April 27, 2020 Public Hearing

Item PUD 2020-0272

BRODYLO FAMILY'S PRESENTATION TO CITY COUNCIL

Overview of Presentation

North Wetland Sub-catchment area = \$02

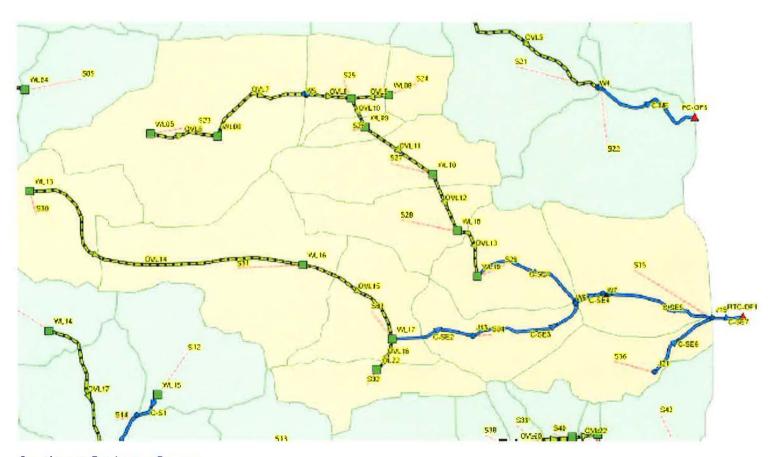
Map from 2020 MDP, shows grouping of S02 with S19-S22 despite Modelling zero discharge due to blocked culvert: = Modelled as Storage, Irrigation = Negative L/s/ha discharge rate
